Jetstream® CPX-1000 Release Notes

Release 3.3.0.1

Document Number 1000-A2-GK41-40
April 2004

New CPX-1000 PDU

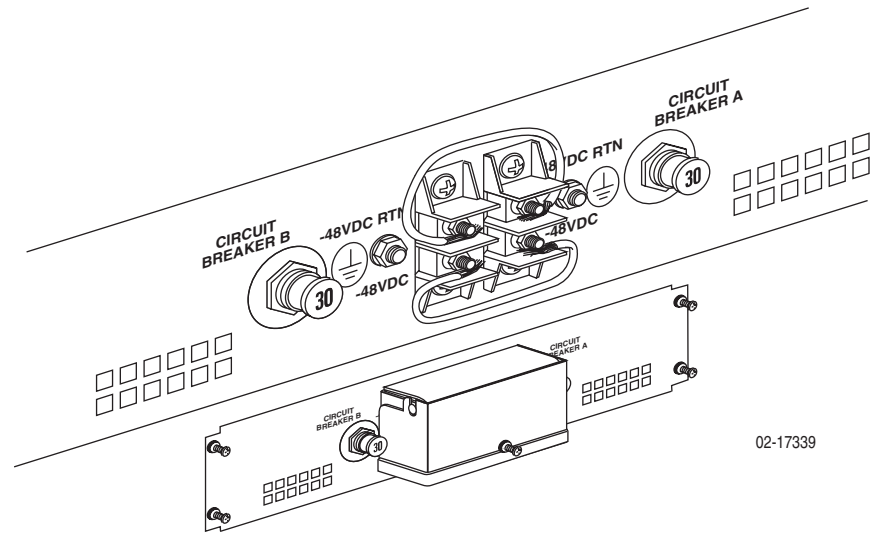
Some models of the CPX-1000 are shipping with a different type of PDU than the one shown in the user documentation.

The new PDU contains two plunger-type circuit breakers instead of one double-pole switch. To remove power from the PDU, pull each circuit breaker plunger out. To apply power to the PDU, push each circuit breaker plunger completely in and release.

The new PDU is shown below.
